7 November 2024

**Information Request Response
P-EA-100658735 and P-PRCP-100669070_V1**

Centurion Coal Mining Pty Ltd (a subsidiary of Peabody Energy Australia PTY LTD) is seeking authorisation to undertake exploration activities which consist of a pilot coal seam gas (CSG) exploration and extraction programme on Mining Lease (ML) 1790. To obtain authorisation for these activities, an amendment to the Environmental Authority (EA) P-EA-100658735 and Progressive Rehabilitation and Closure Plan (PRCP) P - PRCP - 100669070_V1 is required.

FIGURE 3.2

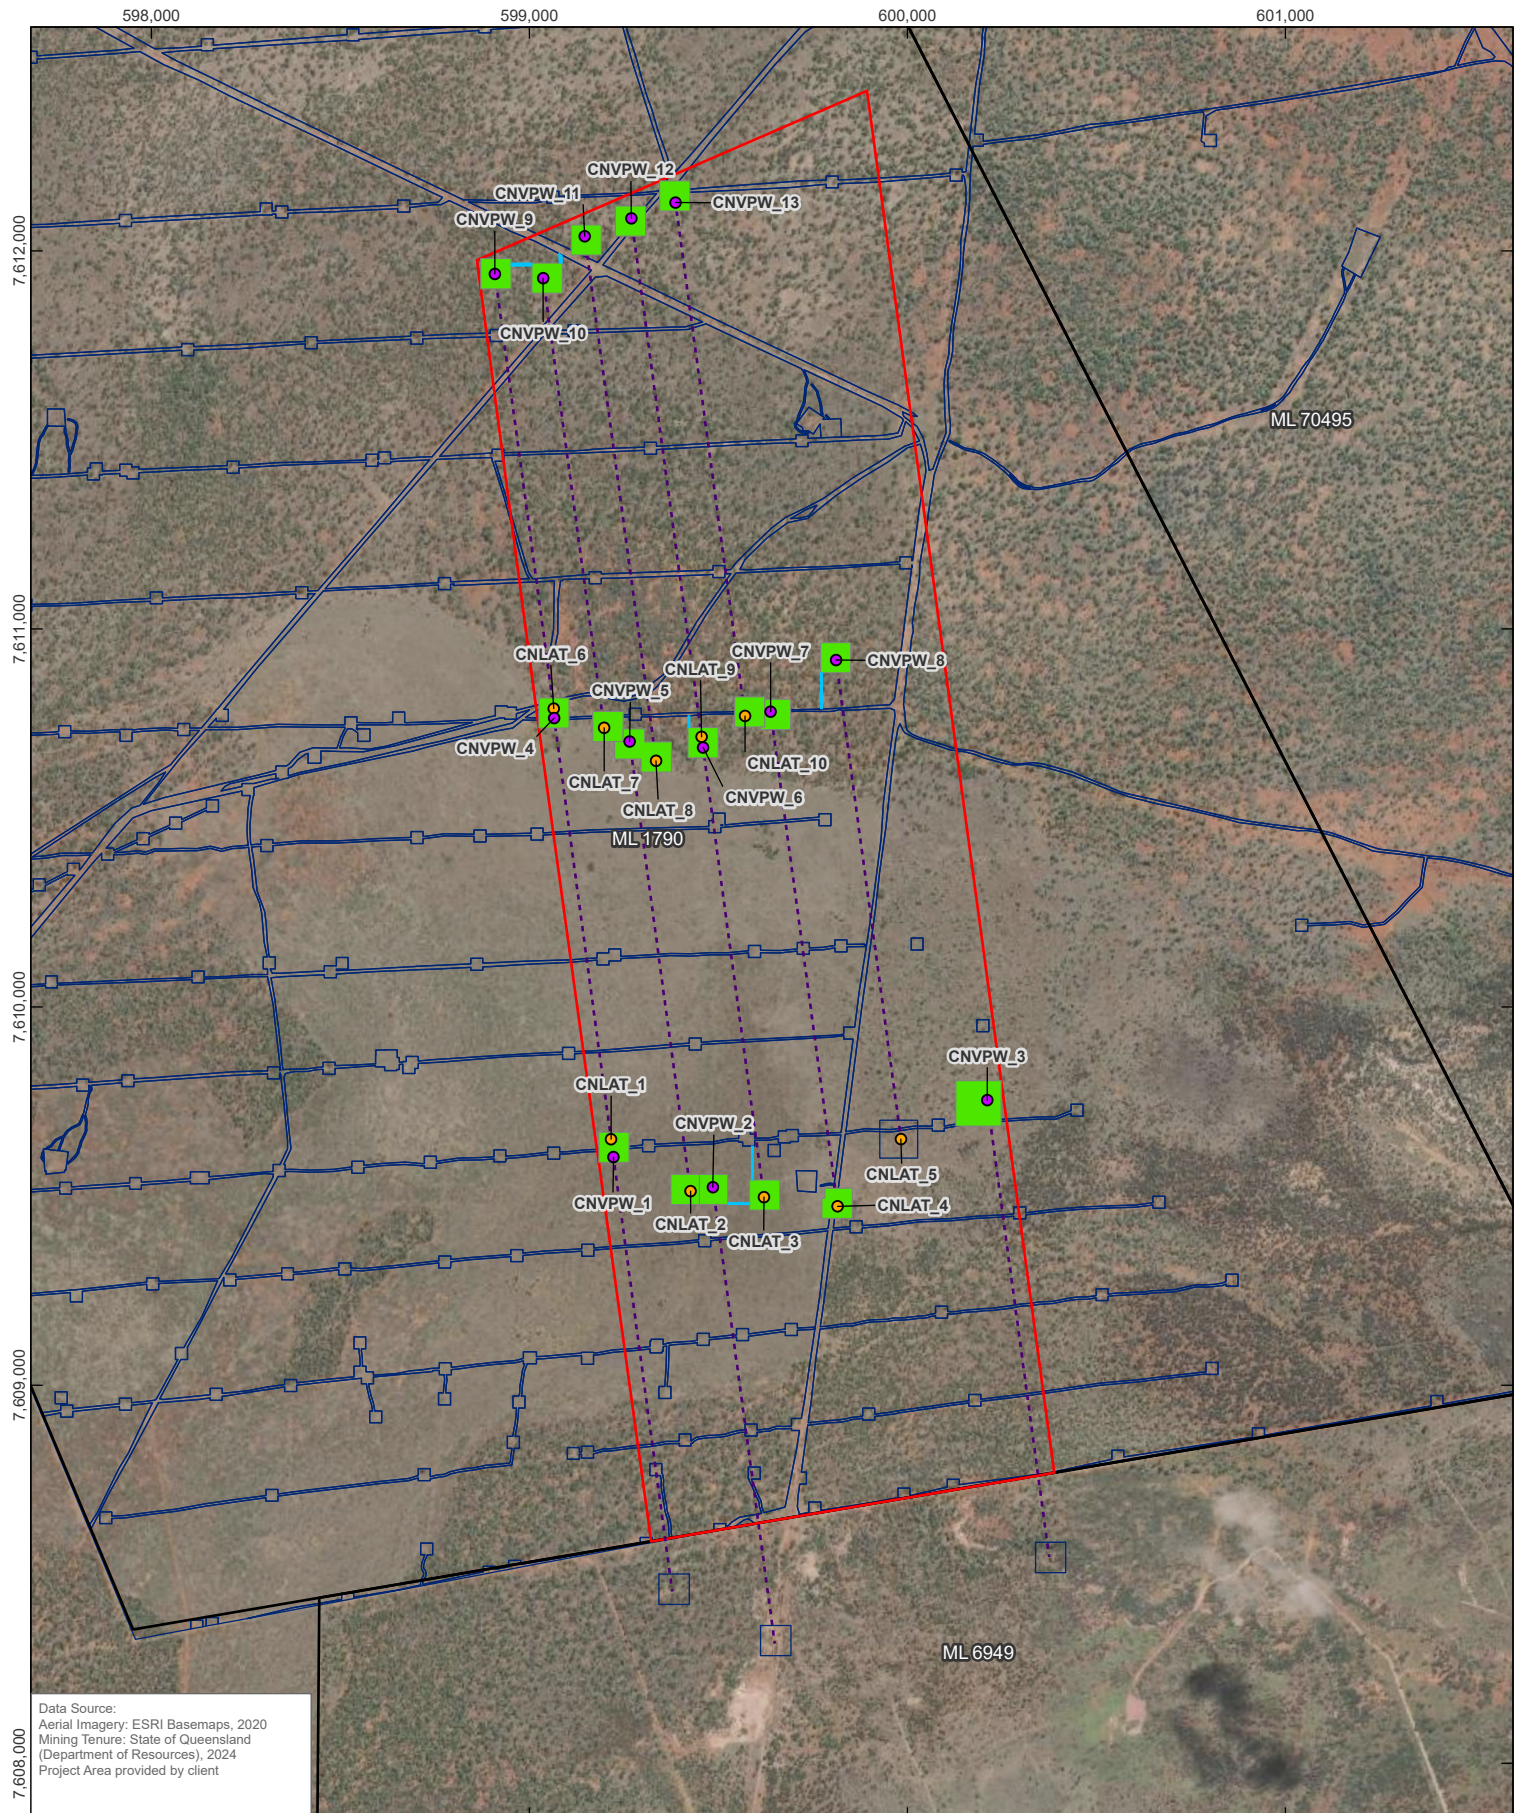
Figure 1 in EA P-EA-100658735 will be updated and replaced by Figure 3.2 of this report.

Existing Condition
Condition F9 would be updated to refer to the drill pads in which the Project activities can be performed. Figure 1 in EA P-EA-100658735 will be updated and replaced by Figure 3.2 of this report. This figure illustrates the location of exploration and mineral development activities.
Justification
The proposed amendment ensures that the variation in activities aligns with the approved disturbance and activities outlined in Table 1 (Mining Activities) and Figures 1 to 4 . The amendment incorporates the Project activities to determine the presence, quantity, and quality of CSG within the GM coal seam and further assess the geological and petrophysical properties of the coal seam (i.e. permeability, porosity).

Existing Condition
Figure 3.2 reflects the following changes to the location and extent of activities for the Project outlined in Section 3 of this report. - Clearing 12 ha of vegetation for drill pads (11.80 ha) and 0.31 km of access tracks (0.20 ha). - Drilling, installing and operating thirteen (13) vertical wells and ten (10) lateral wells across 19 drill pads. - Closure and rehabilitation of the wells.
Justification
The proposed amendment ensures that the variation in activities aligns with the approved disturbance and activities outlined in Table 1 (Mining Activities) and Figure 1. The amendment incorporates the Project activities to determine the presence, quantity, and quality of CSG within the GM coal seam and further assess the geological and petrophysical properties of the coal seam (i.e. permeability, porosity).

FIGURE 3.3

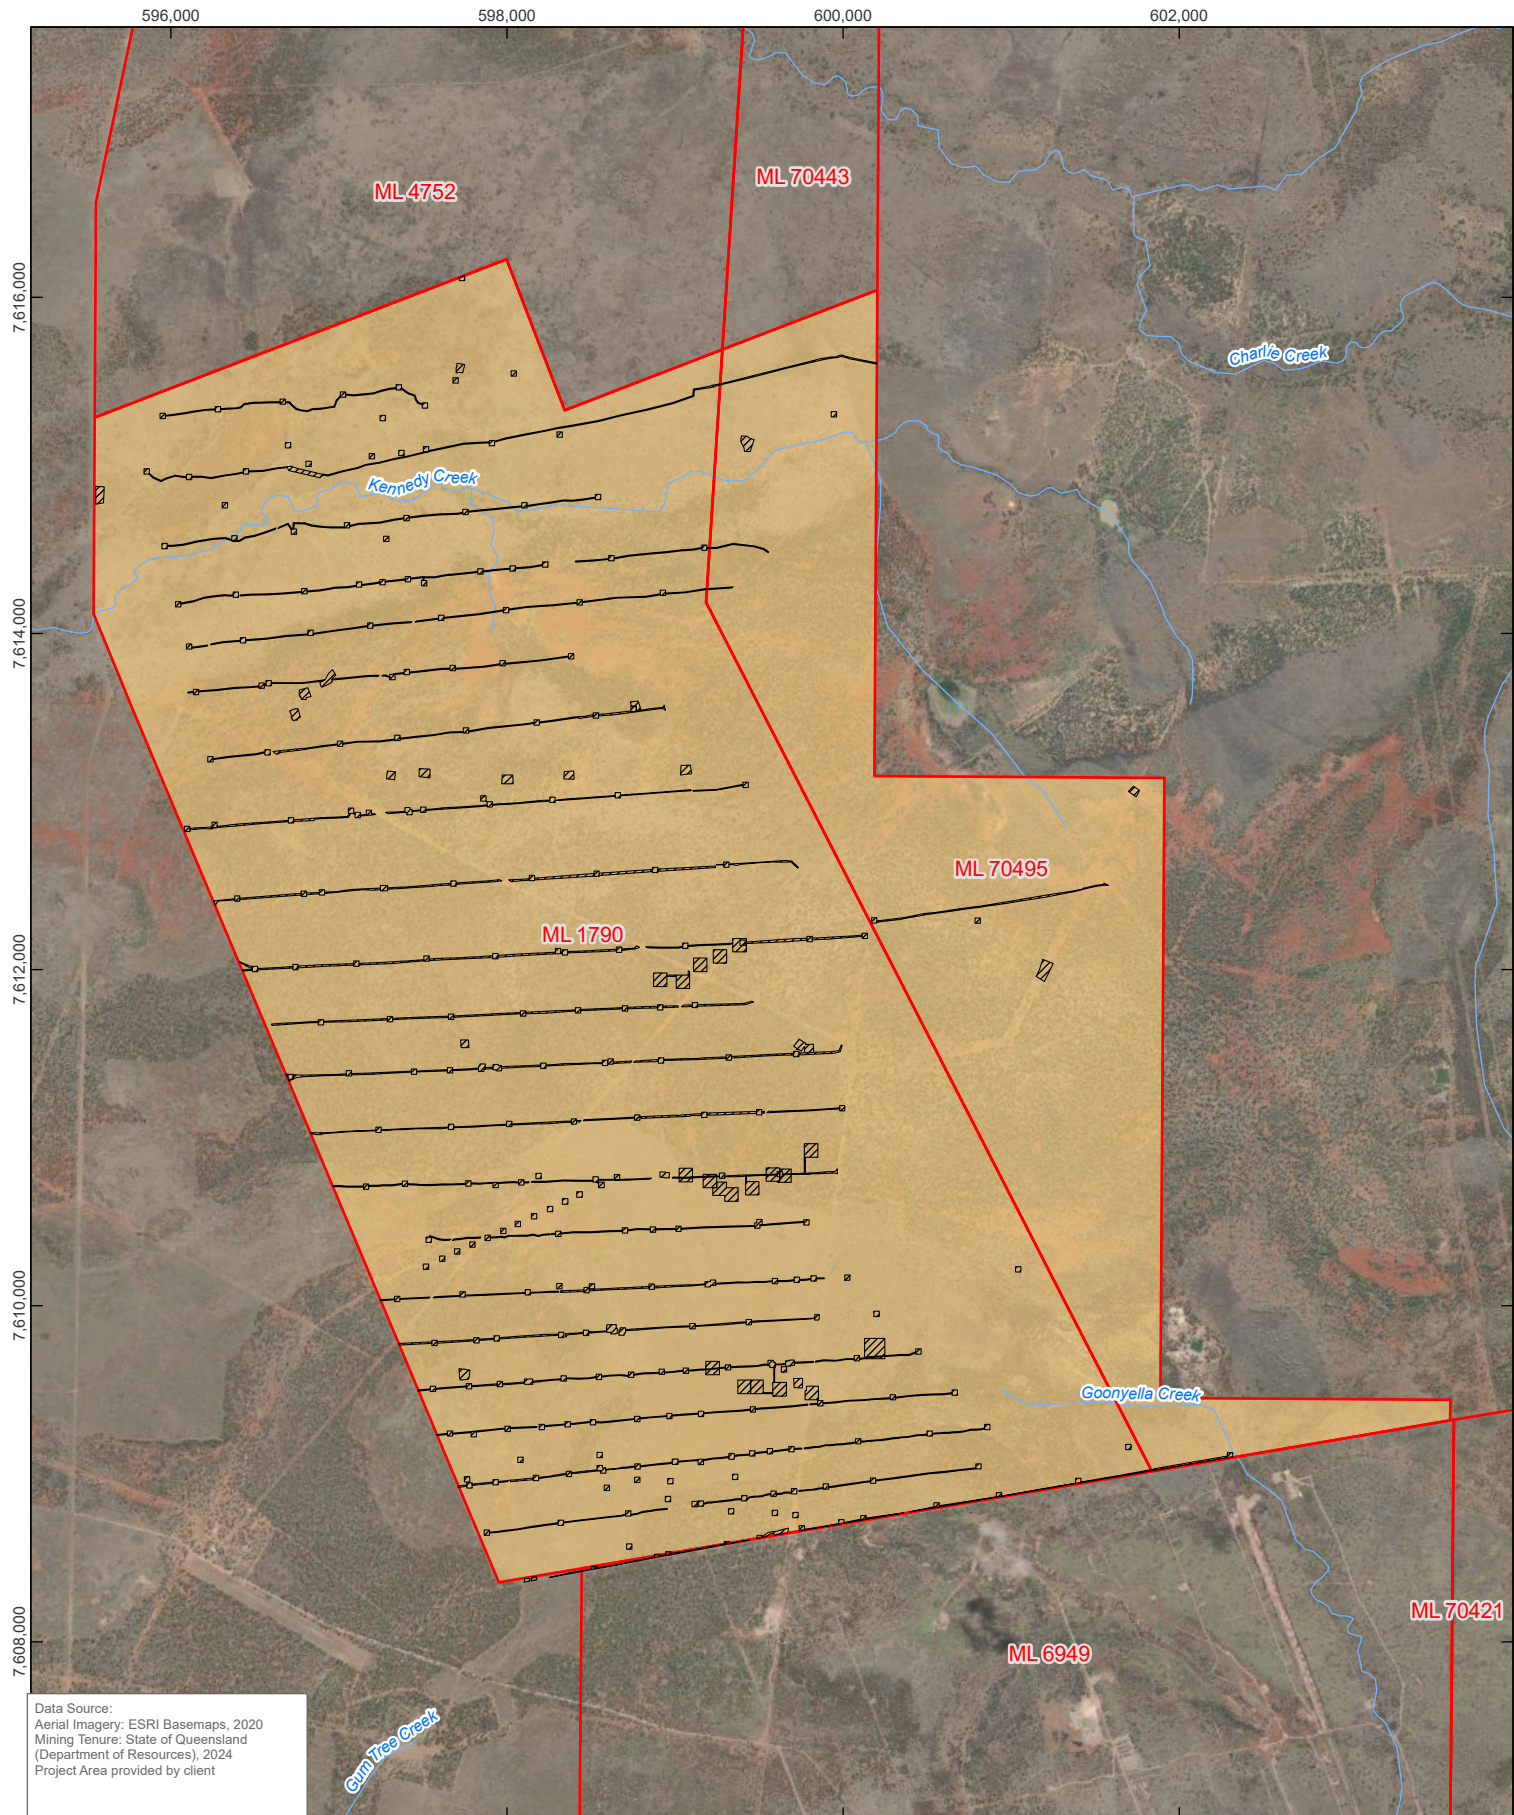
Existing Condition
Section B of the PRCP contains the final site design plans in Figure 1 .
Proposed Condition
No change to wording of condition. Figure 1 referenced in the PRCP is to be amended.
Change
Figure 1 in PRCP P-PRCP-100669070_V1 will be updated and replaced by Figure 3.3 of this report. Figure 3.3 reflects the following changes to the location and extent of activities for the Project activities.
